Arlington Conservation Commission

Date: Thursday, January 7, 2021

Notice of Intent: Arlington Reservoir Master Plan Phase 2, 210 Lowell Street Continued Hearing

RE: Revised Plans and information for Arlington Restoration Master Plan Phase II

Dear Commission Members:

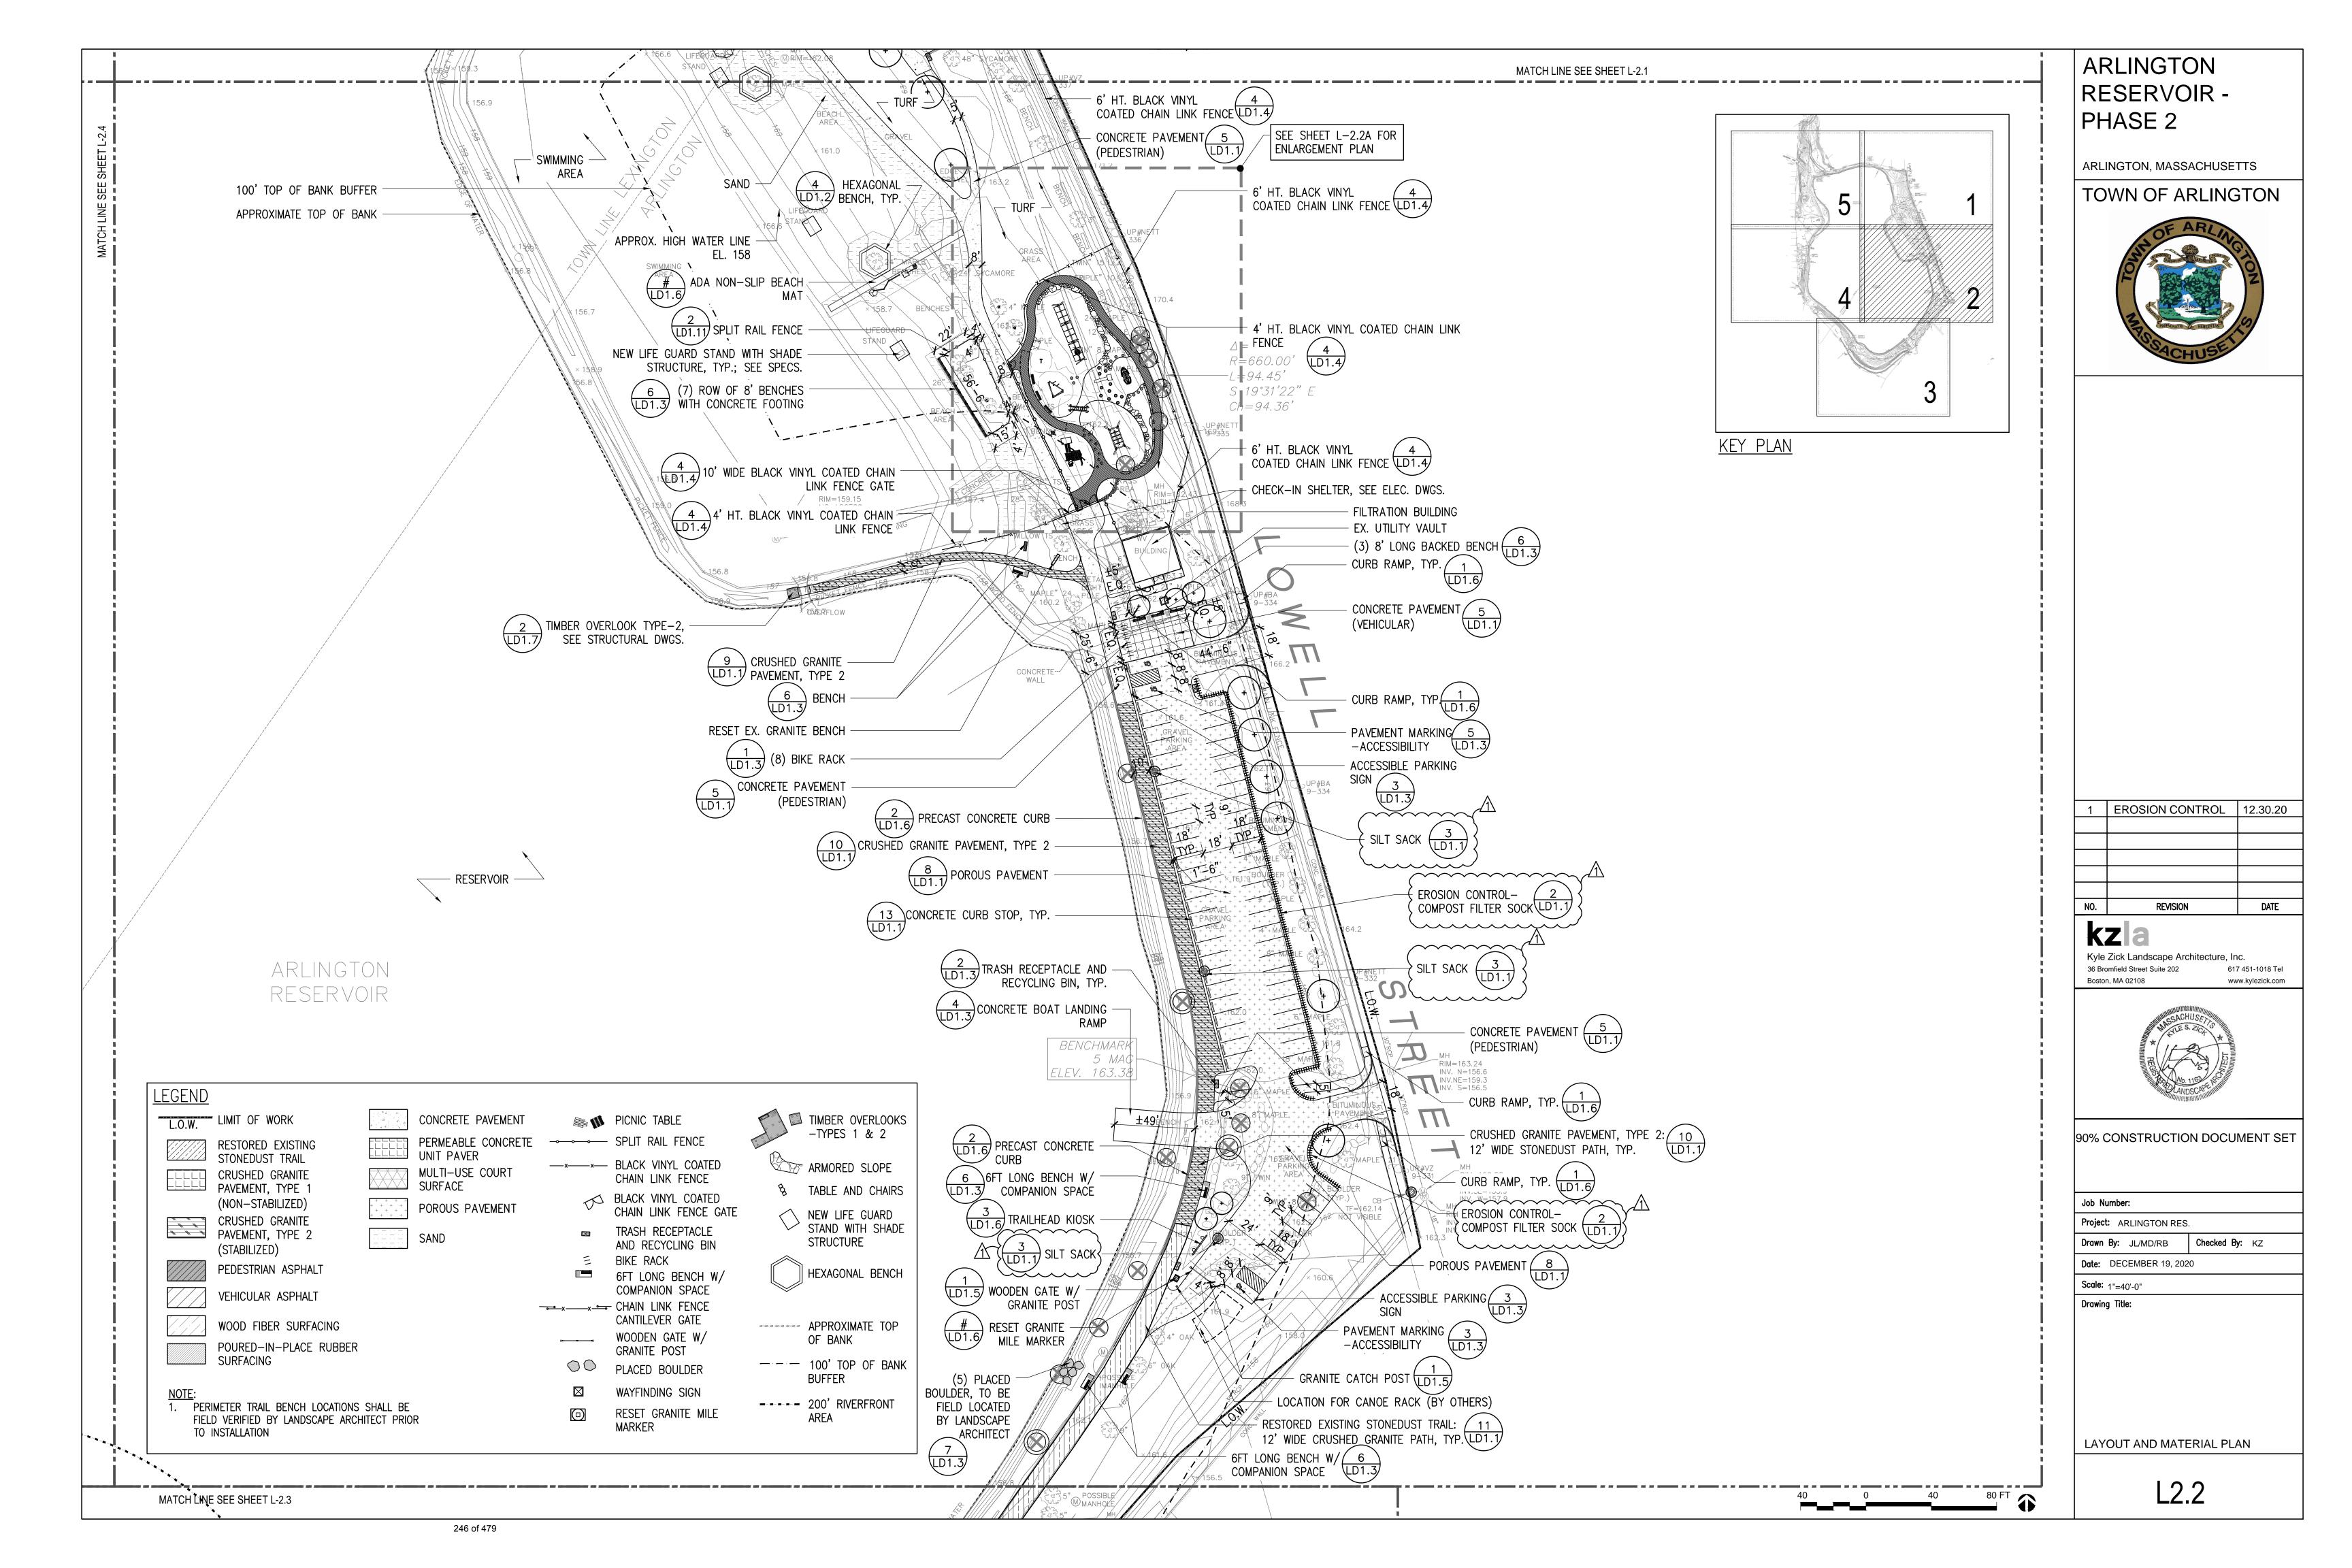
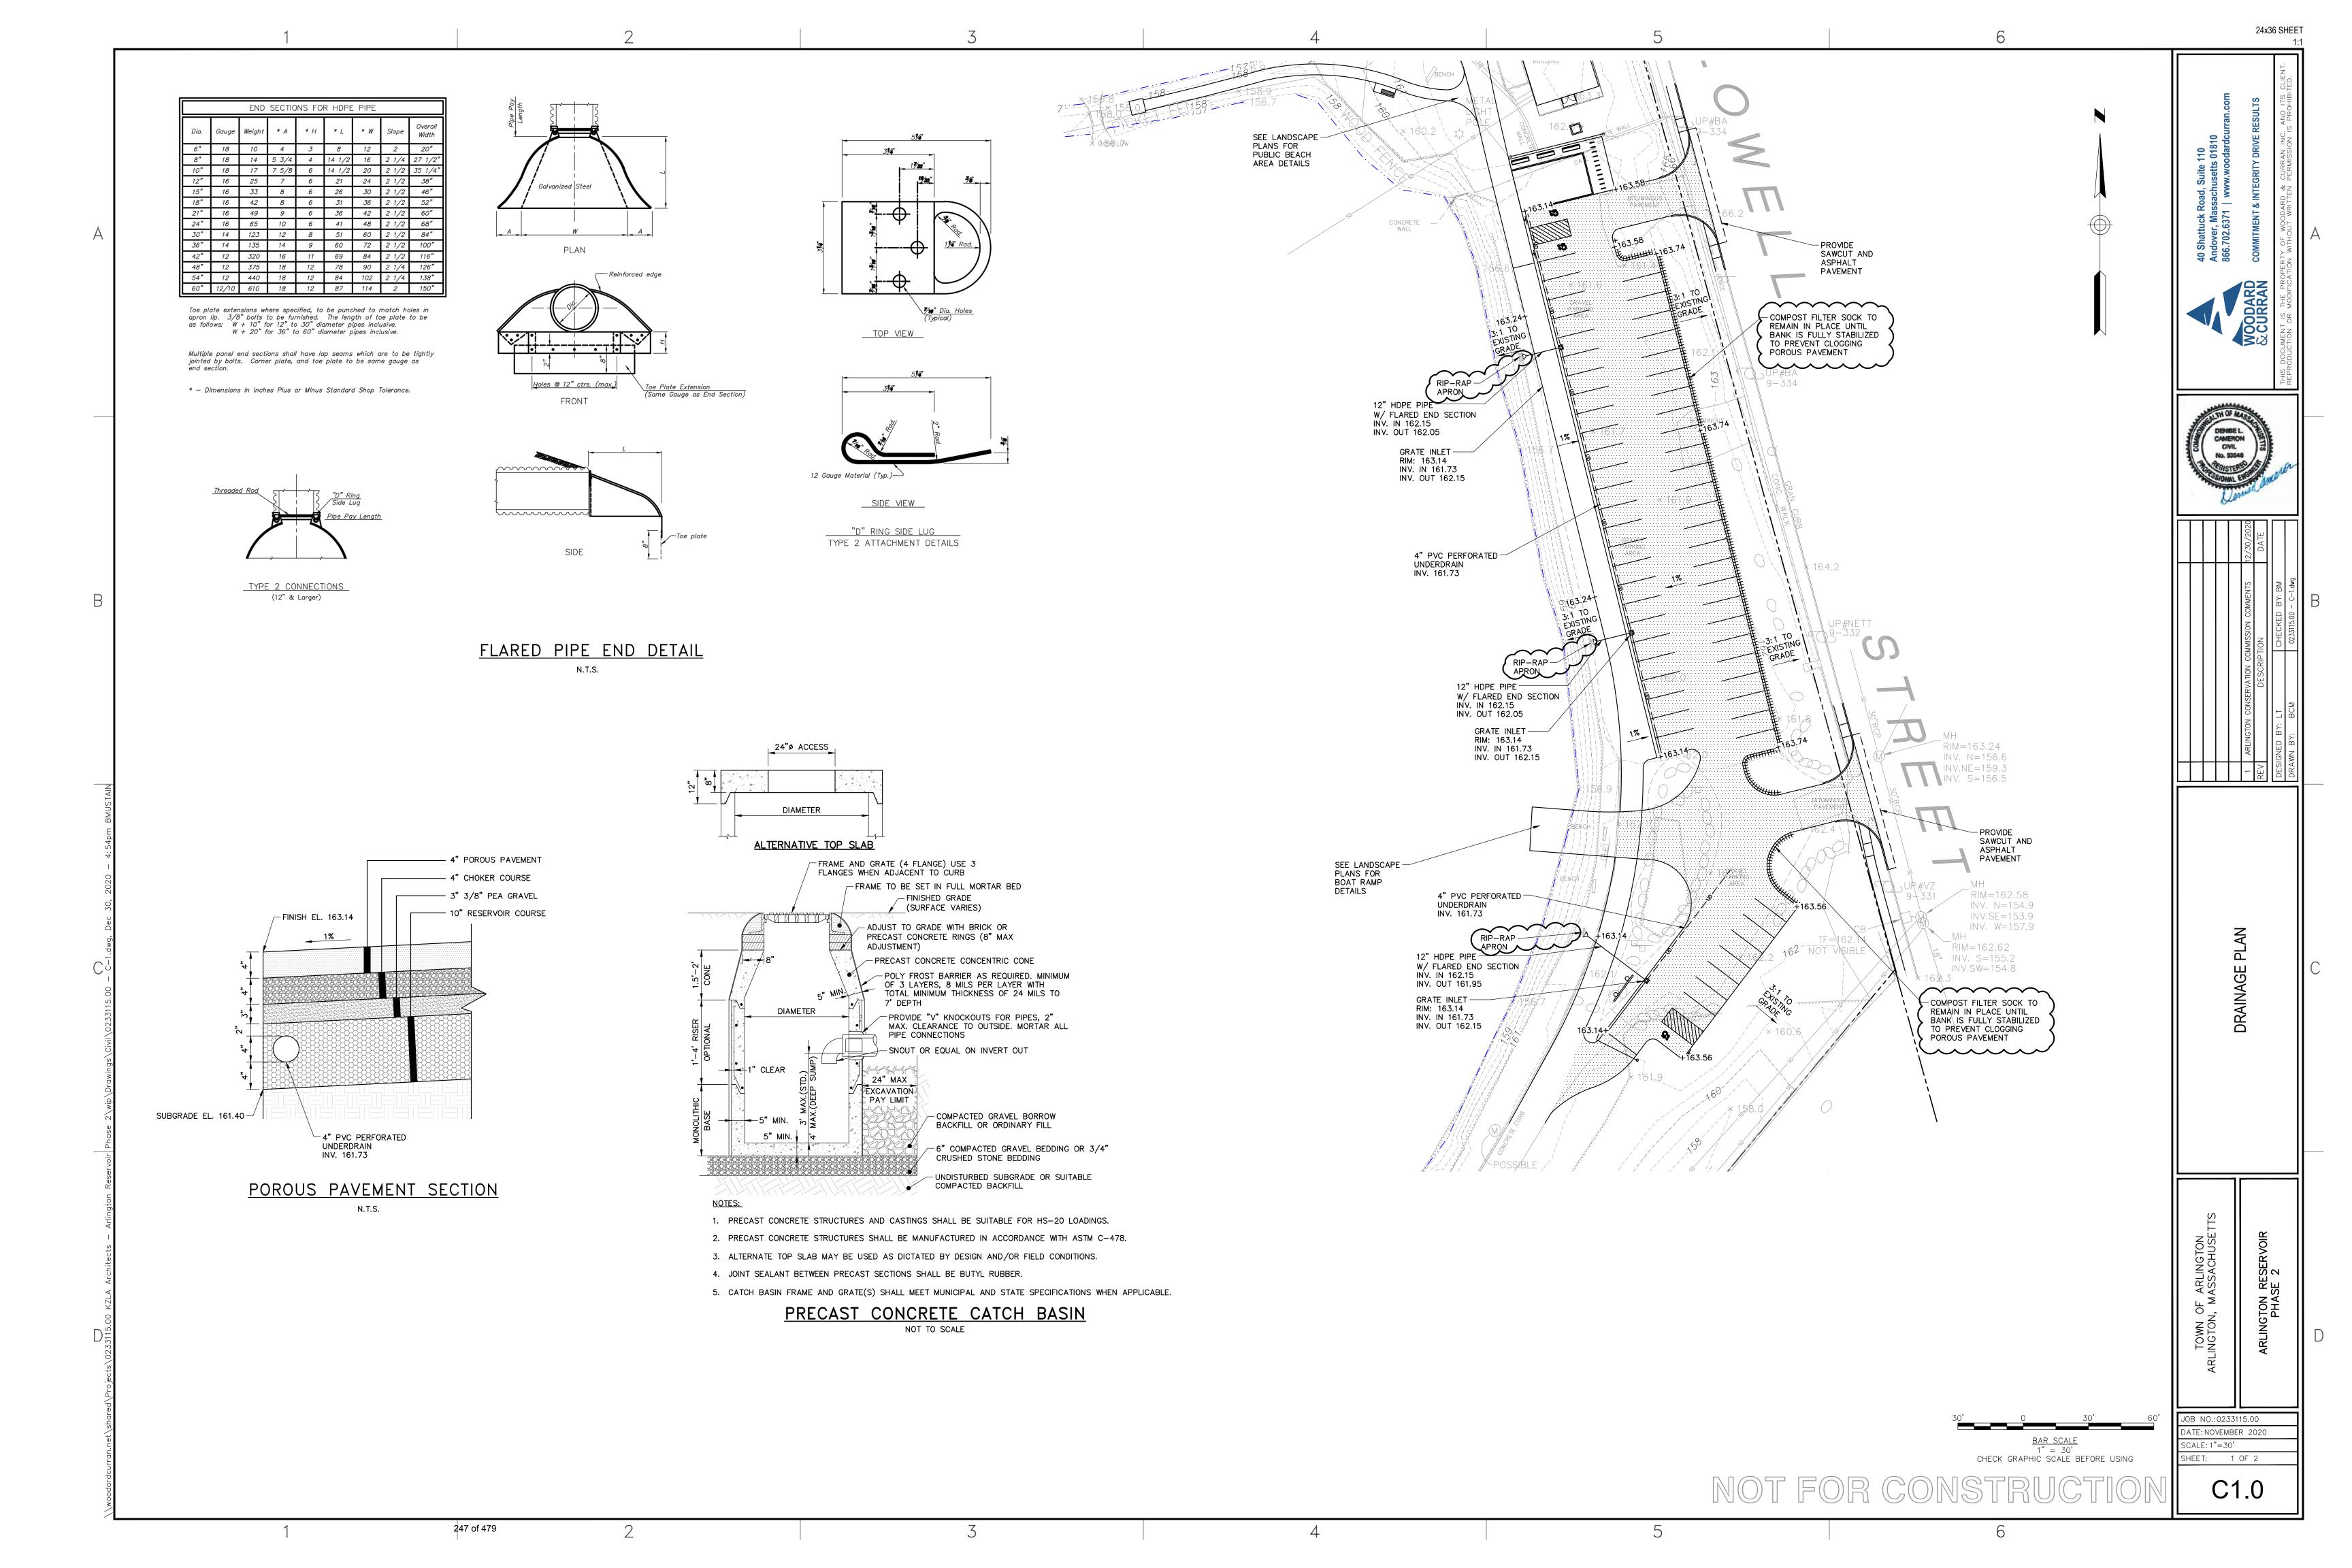
- 1) Information on Lexington's stabilized granite requirements
- 2) Recalculate stormwater calculations using NOAA Atlas 14+
- 3) Review removal/replacement of trees
- 4) Add erosion controls (silt sack) around turf area in parking lot to prevent siltation
- 5) Propose alternatives to glyphosate invasive treatment
- 6) Coordinate with DPW to ensure parking lot is not a snow dump
- 7) Revise parking lot O&M Plan to include regenerative air sweeper
- 8) Revise invasive management to include as much cut-and-dab, not spray, as possible
- 9) Update plan set with changes (erosion controls, plan has erosion control matting near flared end but rip rap might be better)

- 1) Information on Lexington's stabilized granite requirements. A memo from KZLA is attached providing information on this path material and representative examples in the area.

- 2) Recalculate stormwater calculations using NOAA Atlas 14+. A revised stormwater report dated December 2020 is attached. This report has been prepared by Woodard & Curran Engineers and is stamped by Denise Cameron, PE.

- 3) Review removal/replacement of trees. The KZLA memo addresses this item and the planting plans (Sheets L4.1 and L4.5 have been revised. These plan revisions are attached.

- <u>4) Add erosion controls (silt sack) around turf area in parking lot to prevent siltation.</u> The civil site plans have been revised to show compost filter erosion controls socks, and stone rip rap at the outfall pipes. These are shown Plan C1.0 and C2.0. Both revised plans are attached.
